Zion Nuclear Power Station, Units 1 and 2  
Facility Operating License Nos. DPR-39 and DPR-48  
NRC Docket Nos. 50-295 and 50-304

Subject: Submittal of Defueled Safety Analysis Report Update, Revision 7  
Report of Changes, Tests and Experiments

**ZION NUCLEAR POWER STATION  
DEFUELED SAFETY ANALYSIS REPORT REVISION 7**

FIGURE 3-41

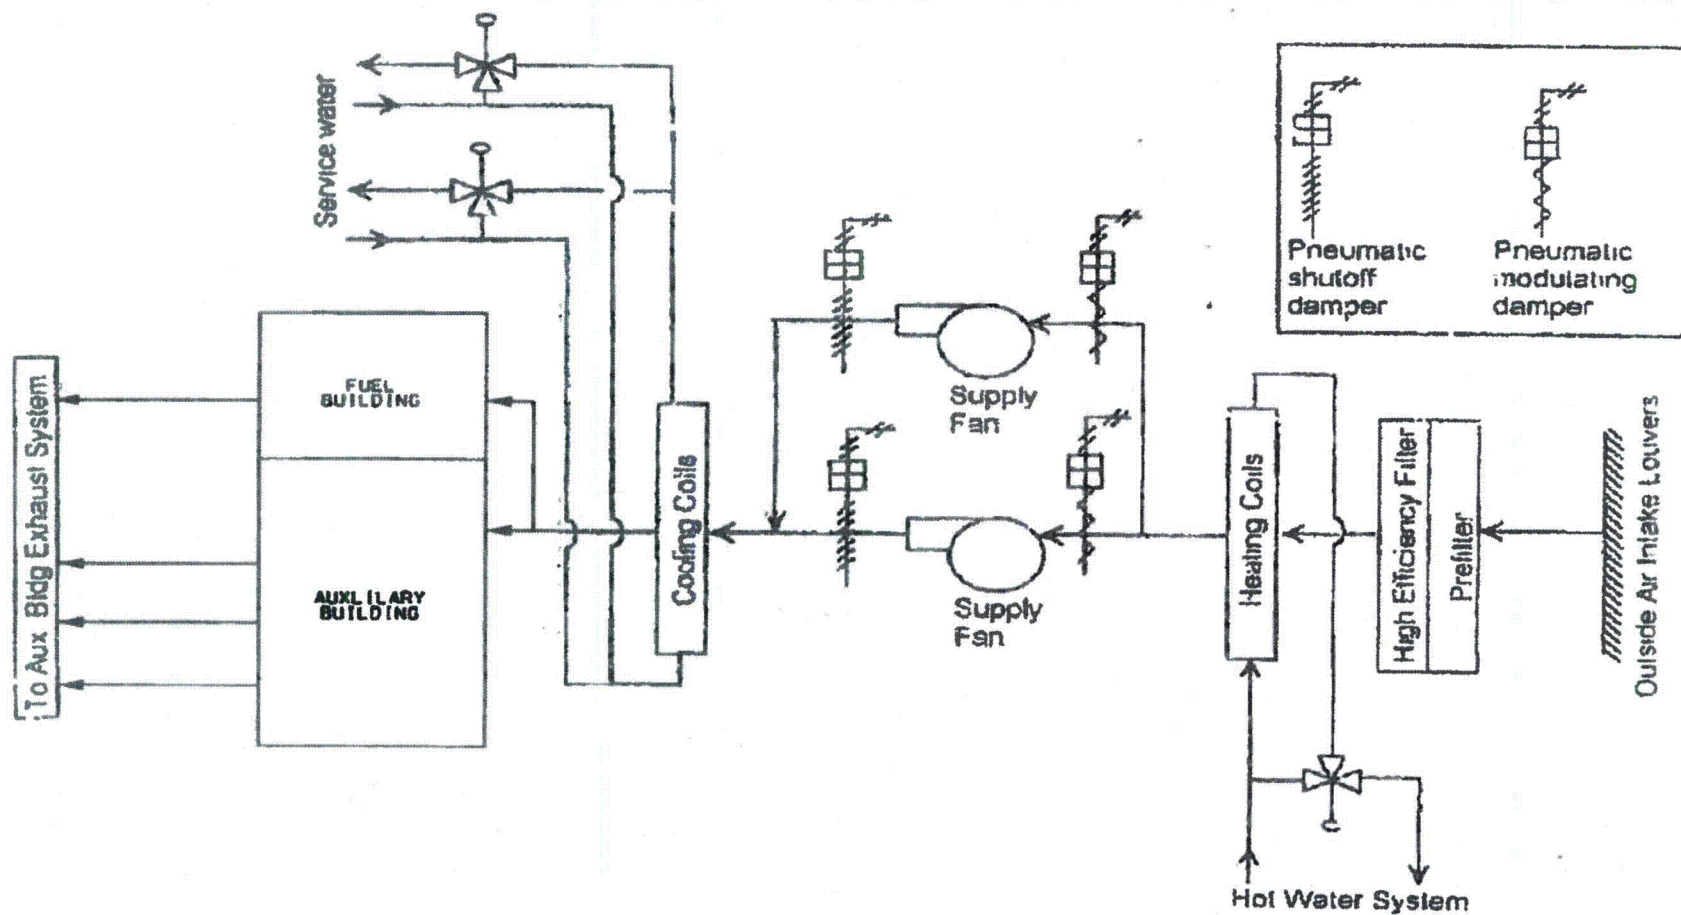
Page 3-21	Add discussion of Containment access opening in support of decommissioning activities.
Pages 1-7, 3-53, 3-55, 3-55a, 3-56, 3-58, 3-59, 3-60, Table 3-15, Figures 1-1, 3-45, 3-46, 3-47	Add discussion of new site auxiliary power supply system.
Pages 3-vi, 3-46, 3-47, 3-48, 3-53, 3-55a, Table 3-14, Figure 3-40	Add discussion of new Service Water Pump installation.
Page 3-29	Correct historical discussion of fuel types used during power operation.
Pages 3-50, 3-51, Figures 3-41, 3-42	Revise Auxiliary Building Ventilation System air flow discussion.

The Auxiliary Building Ventilation system supplies filtered, conditioned outside air to the general areas of the Auxiliary Building and Fuel Building and exhausts filtered air back to the outside. The exhaust fans draw filtered air from the common exhaust plenum and discharges air to the Auxiliary Building vent stack past a radiation sampling monitor. The exhaust system can operate to maintain the pressure gradients by vortex control dampers and the operation of one or more exhaust fans. Individual filter units treat the exhaust from miscellaneous areas of the Auxiliary Building prior to discharge via the main exhaust fans. See figures 3-41 and 3-42.
